3.0 Design process

3.6 Consultation process

3.6.1 Pre-application 1 - 3rd May 2019

Sketch plan of proposals - Pre-application 2

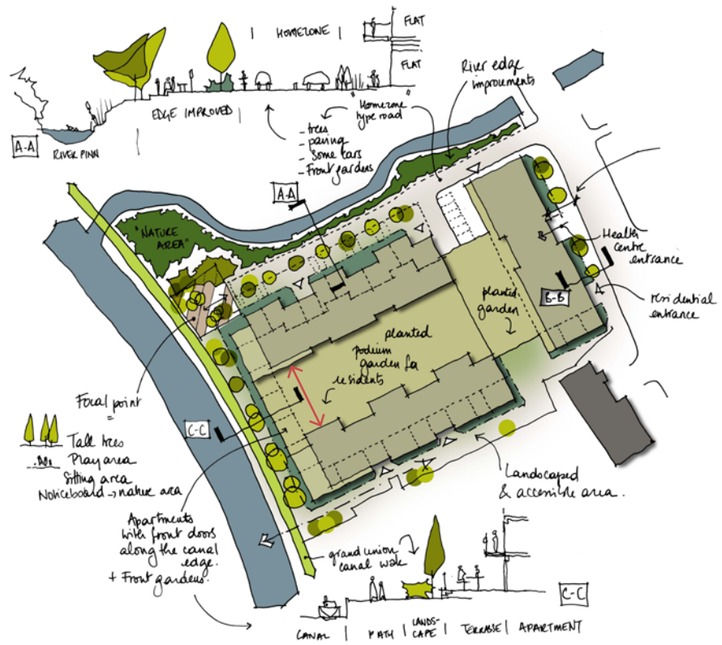
- Building along High Street still feels too high
- A decent set back along High Street required to accommodate new cycle path. Move building line back from street edge
- LB Hillingdon noted there was an option of exploring greater height along the canal
- LB Hillingdon very keen on Health facility and willing to make some compromise to deliver this
- LB Hillingdon noted they appreciated the gable ends fronting the canal as this mitigates against a 'wall' of development along the canal edge

- Remove pitched roofs to minimise building heights along the High Street
- Building line along High Street pushed back to provide generous public realm area in front of Health facility.
- Client to review project viability to include Health facility and Cycle route proposals. LB Hillingdon noted that the Hillingdon CCG (Clinical Commissioning Group) should be included in discussions about the Health facility.

Ground floor plan of proposals - Pre-application 3

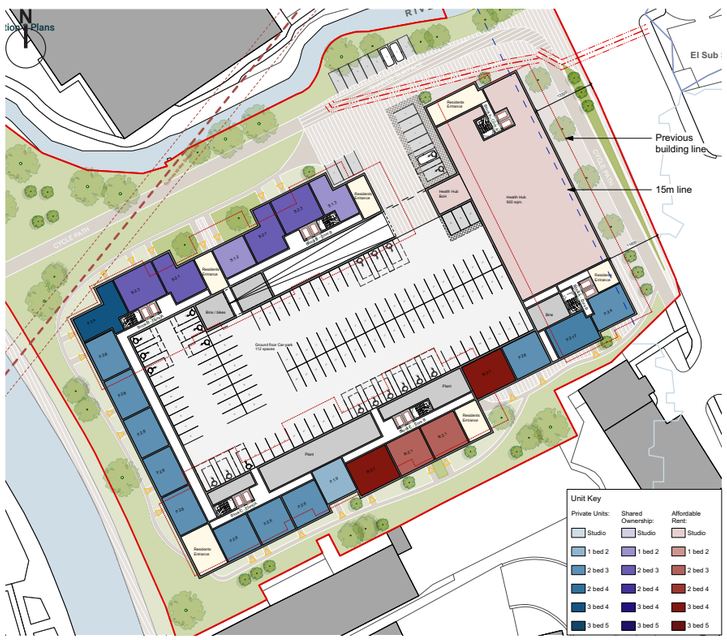
- The application should demonstrate how emerging Policy DME 2 (Employment Uses Outside of Designated Sites) has been taken into account
- Hillingdon CCG to be included in further discussions about the Health facility in order to ensure the scheme is built for purpose and can be successfully occupied upon completion

- A sequential test needs to be carried out to demonstrate that there is clear justification for developing this area ahead of sites at a lower risk of flooding

- On-site drainage needs to achieve as greenfield run off rates through sustainable options
- The proposal will be required to achieve 35% affordable housing subject to viability if providing less

- It is considered essential that the site delivers a greater proportion of family homes as part of the proposals (3+ bedrooms).
- There should be a 15m set-back along Yiewsley High Street for residential units.

- The proposed buildings would benefit from being 'broken up' so they appear less 'blocky'
- The use of brick is encouraged as is the use of high quality materials

- It is noted and supported that the entrance from the Canal is looked at as a key focal point from the canal and start of the Celandine walk
- Car-parking should be kept away from the River edge

- The proposed cycle lane is welcomed as are the improved links from the west of the site to the Grand Union Canal

- Rain gardens provide a soft landscaped buffer to cyclists and pedestrians
- New Health facility provides active frontage along High Street
- New street trees proposed
- New two-way cycle route

Exhibition boards presented - Public exhibition

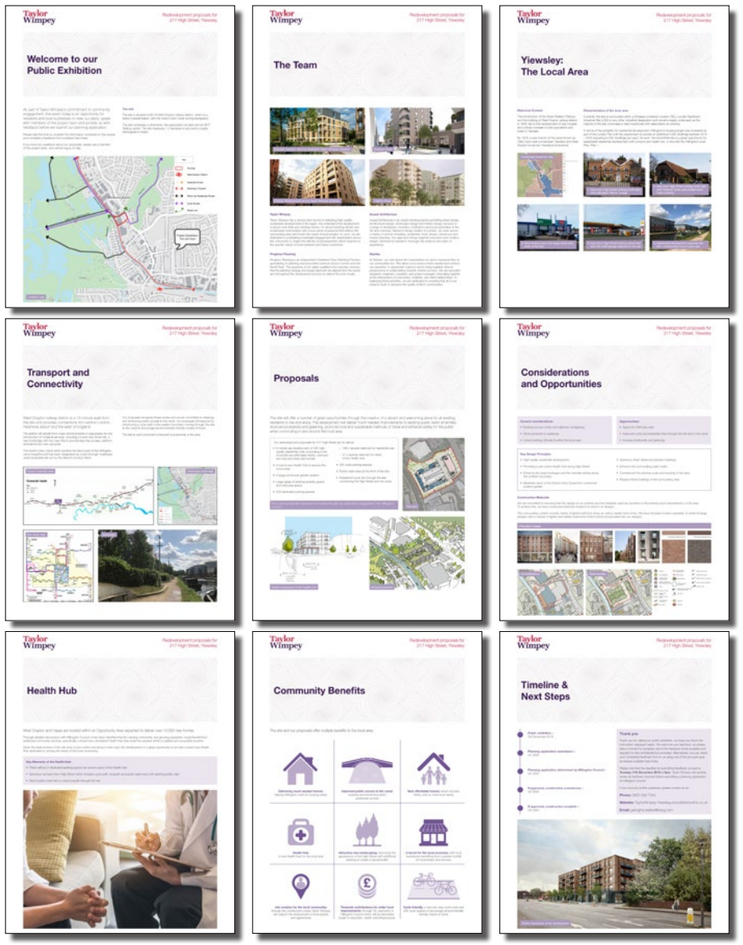
- Unanimous support of Health facility
- Maximise provision of car parking spaces
- Positive comments regarding opportunity to incorporate car club spaces
- Unanimous support of improving access to the canal
- Concerns that affordable housing provision will not be truly affordable, particularly to the younger generation
- Comments on the density of flats in scheme, proposing that the site would benefit from additional retail or leisure facilities
- Support of use of materials and high quality design

- Internal layout of Health facility developed
- Car parking spaces increased to practical amount to satisfy both GLA and LBoH
- Car club spaces incorporated in car parking strategy and visitor spaces
- Celandine route connecting Yiewsley High Street to the Grand Union canal developed further and alongside landscaping strategy, to create a visible and inviting route through site
- Affordable provision increased
- Studies developed to vary block heights to individual blocks to improve legibility and way-finding across the scheme.
- Design developed to promote Health facility projection
